REVISIONS MADE BY THE CITY OF SAULT STE. MARIE

PROJECT:
 99 MELVILLE RD,
 SAULT STE. MARIE, ON
 P6A 5J6

DRAWING TITLE:
 SITE PLAN

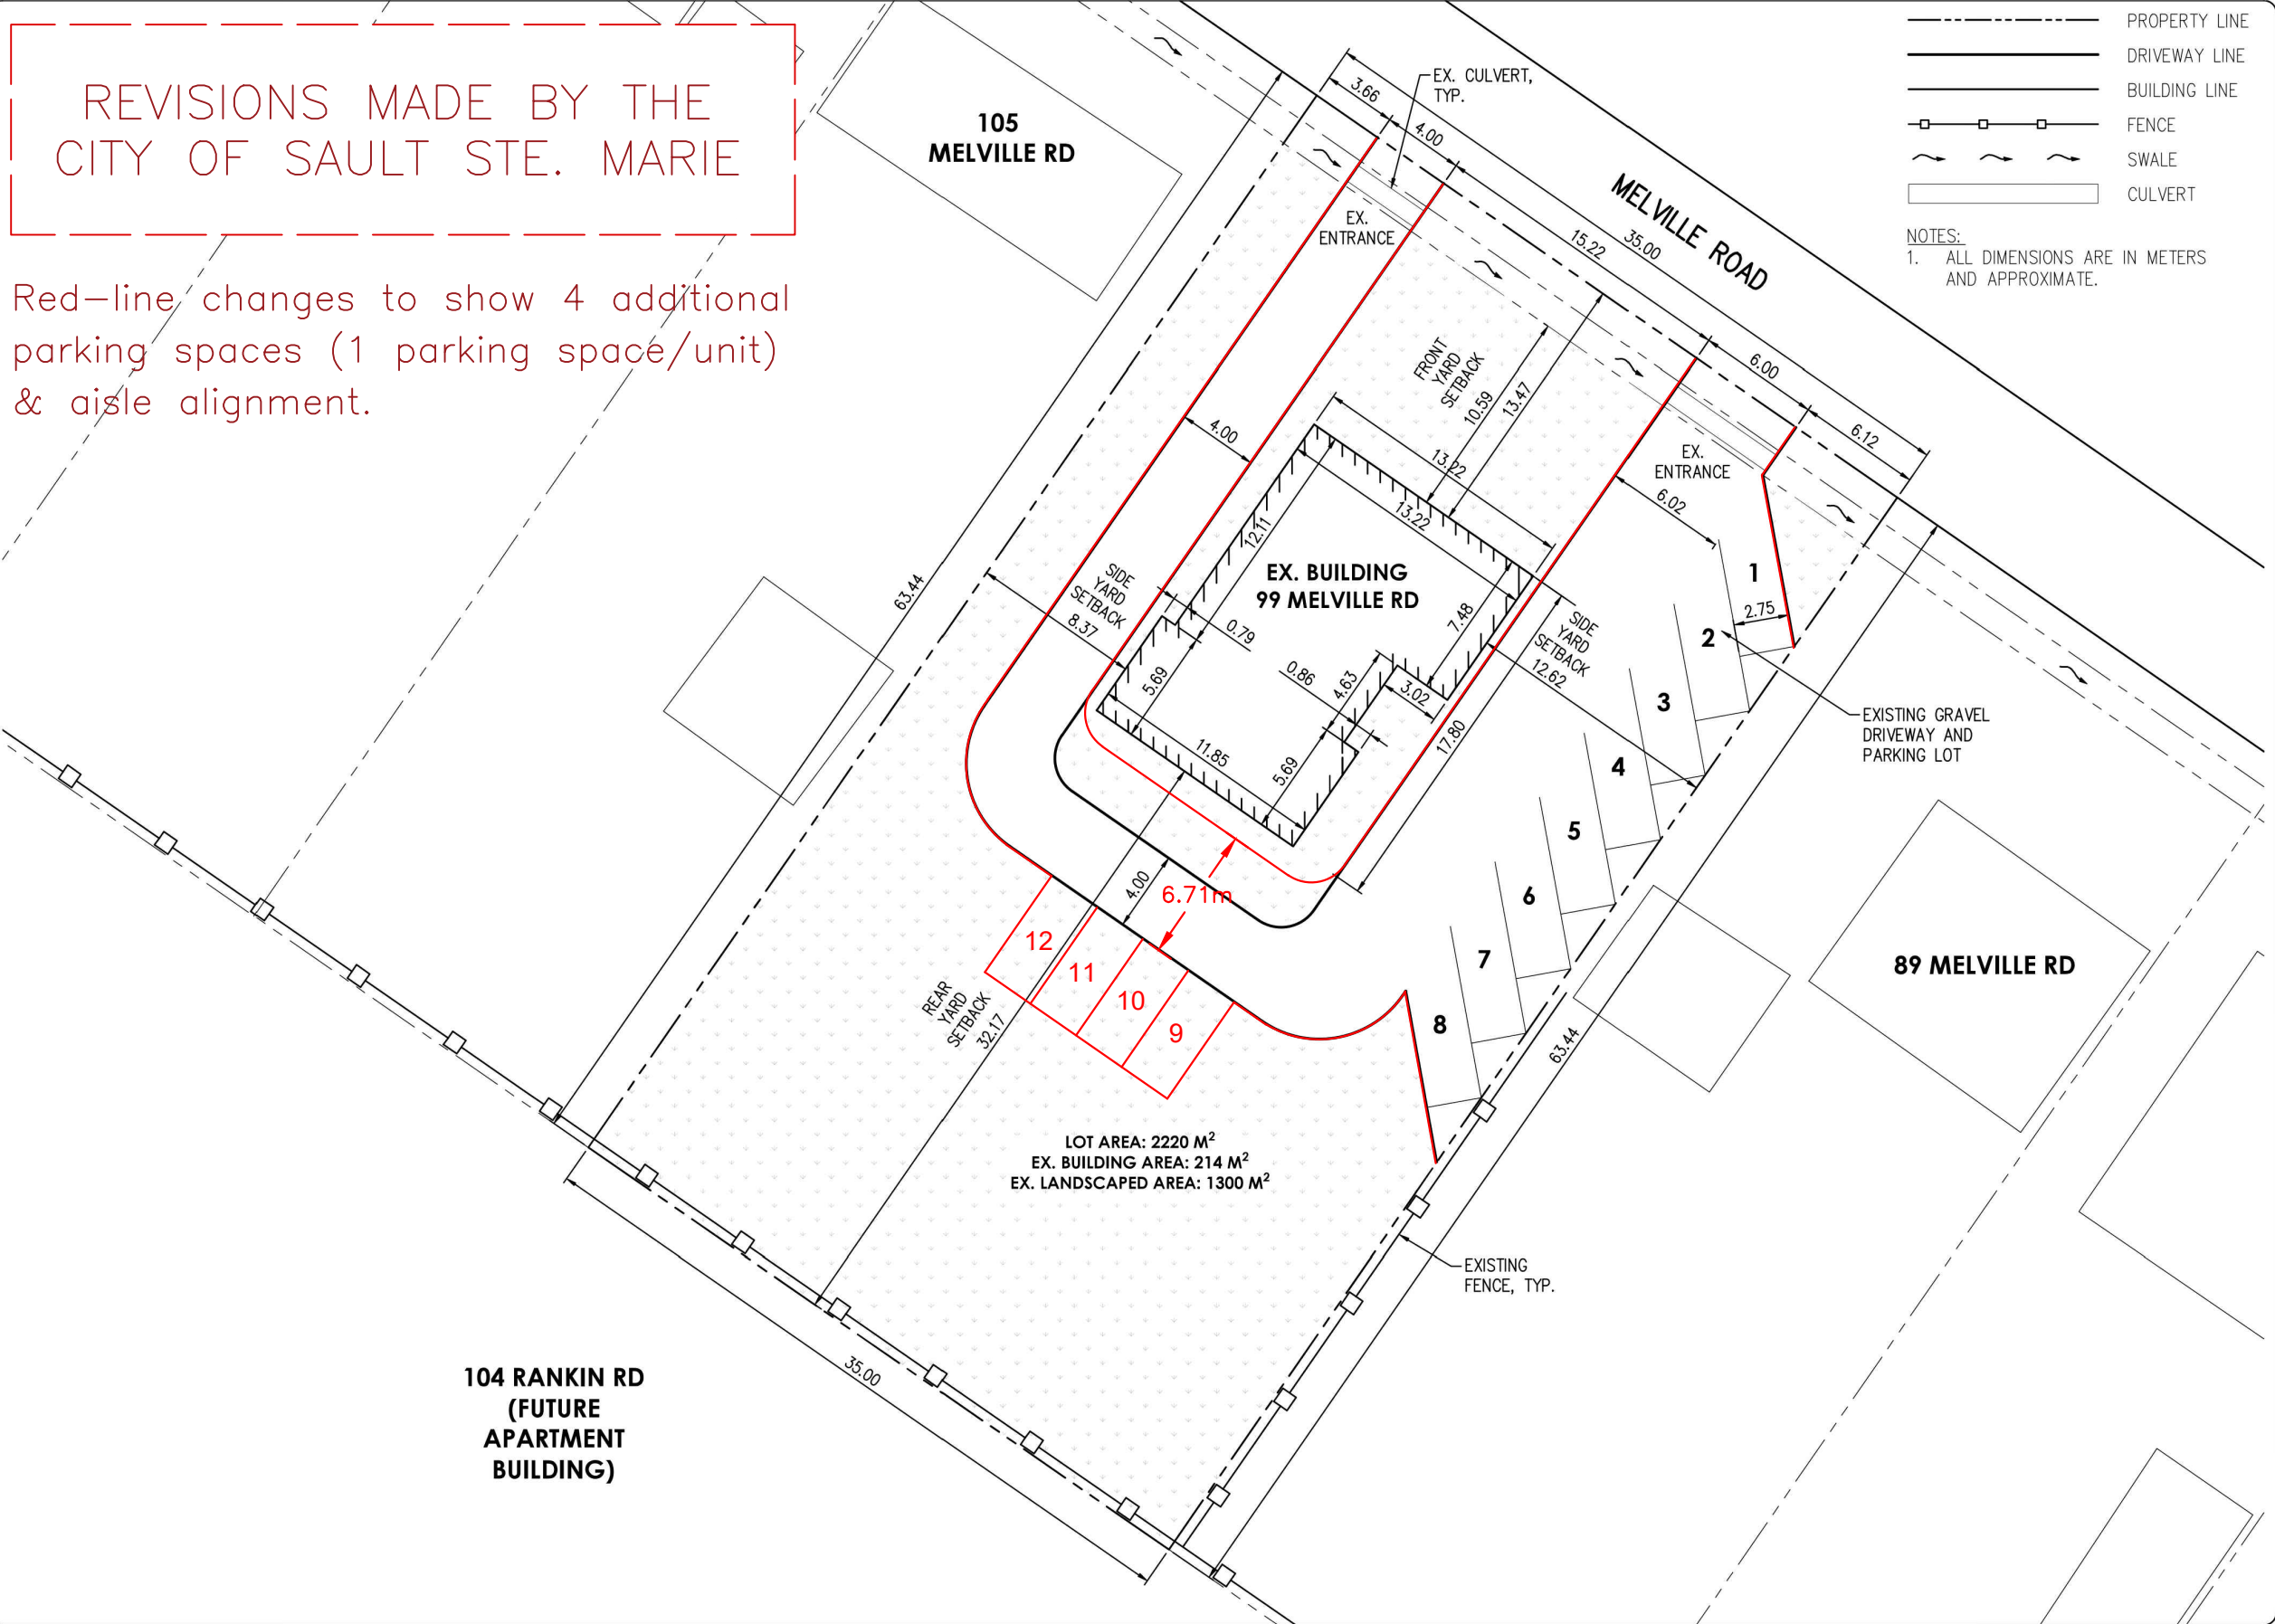
Red-line changes to show 4 additional parking spaces (1 parking space/unit) & aisle alignment.
